CITY OF  
**West Linn**  
 PLANNING AND DEVELOPMENT

**STAFF REPORT  
 PLANNING DIRECTOR DECISION**

FILE NO.: DR-12-16/SGN-12-24

REQUEST: Class I Design Review approval of a replacement garbage compactor and enclosure, the re-purposing of a shallow wading pool in the former Sunset Park area into an amphitheater with pergola, and the installation of perimeter fencing and signs at Sunset Elementary School at 2351 Oxford Street.

**SITE KEY PLAN** ①  
 SCALE: 1/8" = 1'-0"

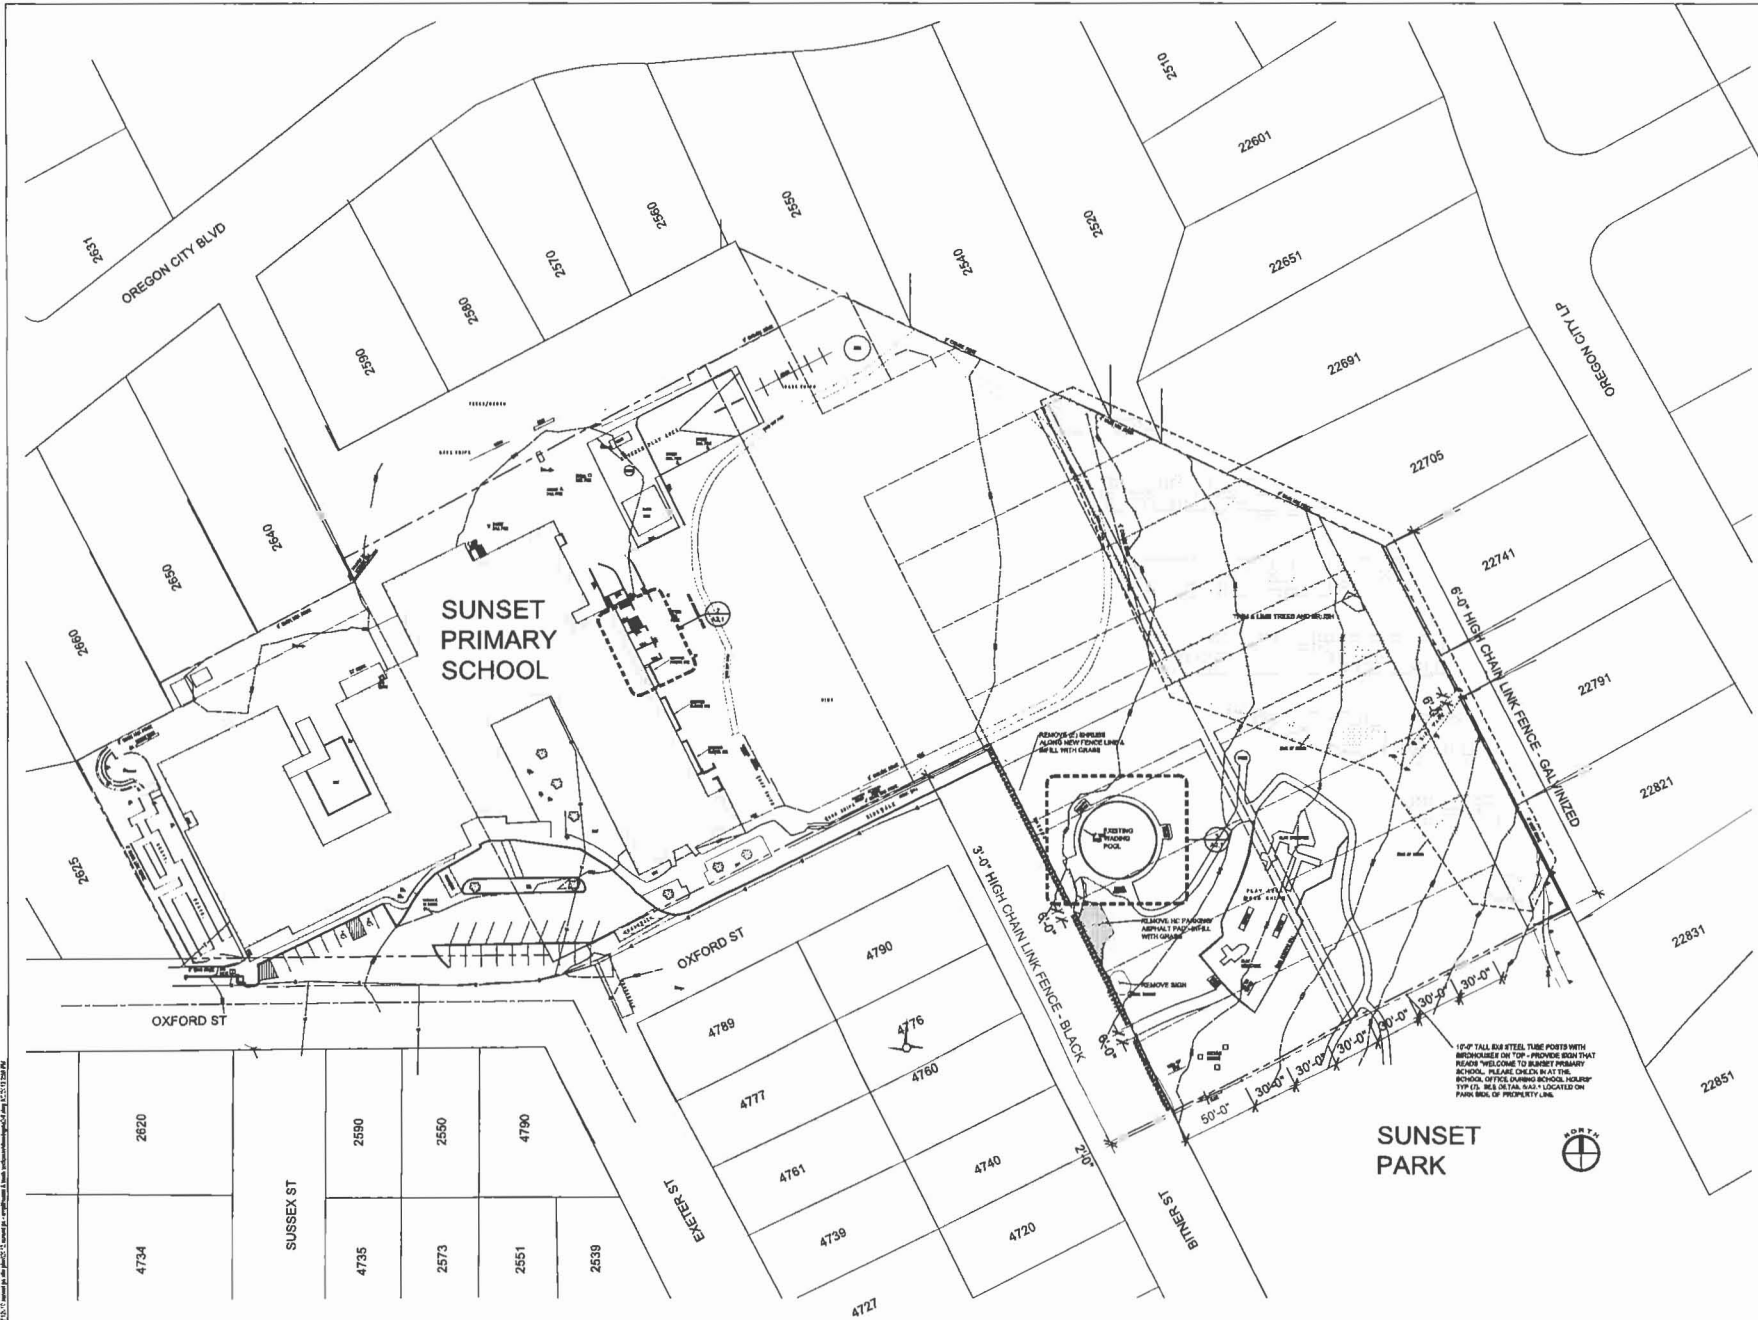
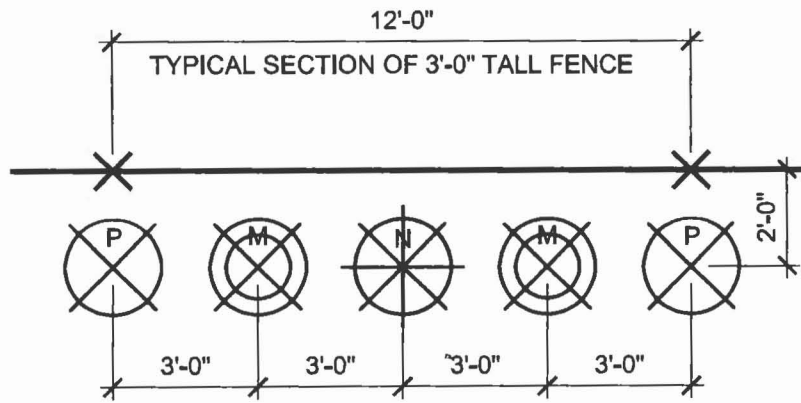
**The school district will be installing perimeter fencing on the east and west sides of the former park. The fencing will make it clear that this is a semi-private space. The cyclone fence on the east side will be six feet high while the cyclone fence along Bittner Street will be three feet high. To delineate the southern property line, the district proposes a novel idea: install seven ten foot high metal posts with bird houses on top. The posts will be about 30 feet on center with small 6” X 6” signs at four feet above grade explaining that this is school property and that visitors must check in at the school office. *There will be no fence along the south property line.***

**On the east side of the former park property there is a 30 foot wide trail corridor that connects to Oregon City Loop. It is identified on the Villa Roma subdivision plat as “Tract B Pedestrian Walkway”. The preservation of this walkway or trail is required for connectivity purposes, to meet the Transportation Planning Rule and facilitate the “Safer Routes to**

School” program. Consequently, the fence on the east property line must be built with an appropriately sized gap or gateway to allow, and encourage, continued use of this route.

1. Site Plan. The improvements shall conform to the applicant's submitted plans for "Amphitheater and Trash Enclosure" (Sheet A2.0 and A2.1) dated August 2012.
2. Footpath from Oregon City Loop. Access to the school property from Oregon City Loop via the footpath on tax lot 13700 of Assessor's Map 21E 25DD shall be maintained.
3. Noise. Sound amplification may not be used in the amphitheater area. DEQ noise standards shall be met at the school boundary.

**PLANTING DETAIL** (6)  
1/4" = 1'-0"

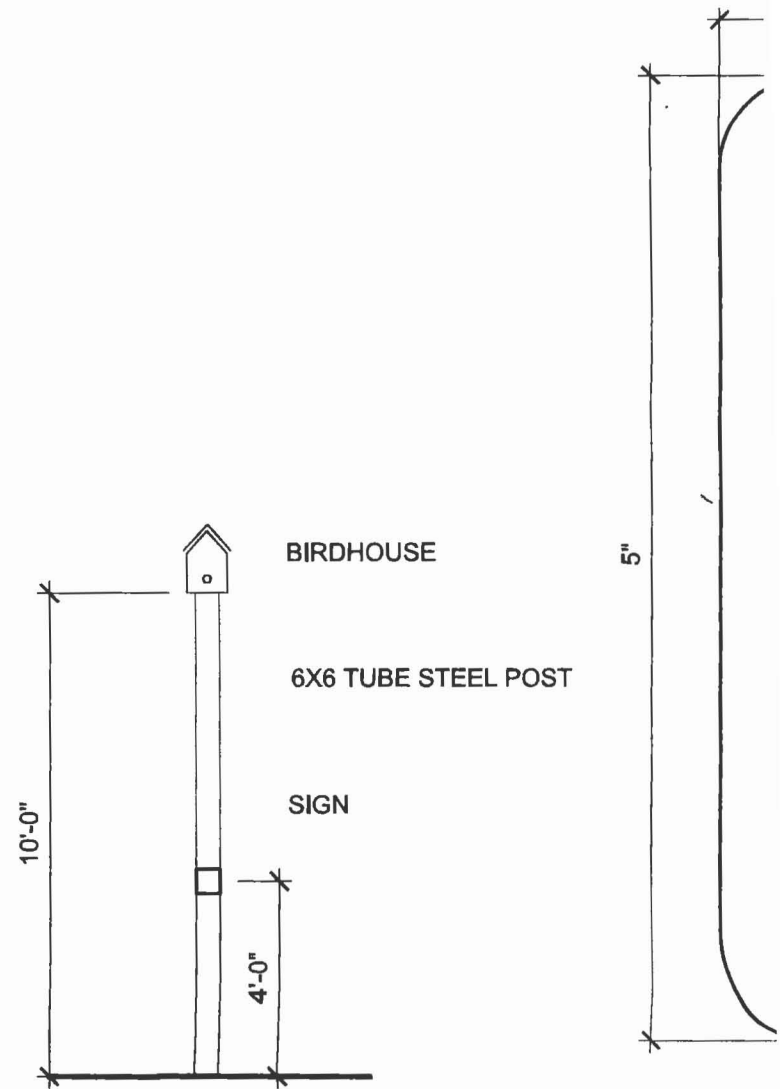
The applicant’s selection of slow/low growing replacement trees and shrubs (nandian compacta, mugito pine and pieris japonica varicata), to be planted along the fence line should work well but they may need trimming/pruning to maintain lines of sight to the amphitheater/pergola area.

*(Public proposals to keep the existing hedge and trim it down to an acceptable dimension are good but the district is apparently committed to a fence and the fact that the hedge runs right down the property line means that a fence delineating that line cannot be built without removing the hedge. Unlike trees, hedges and shrubs are not protected by the CDC.)*
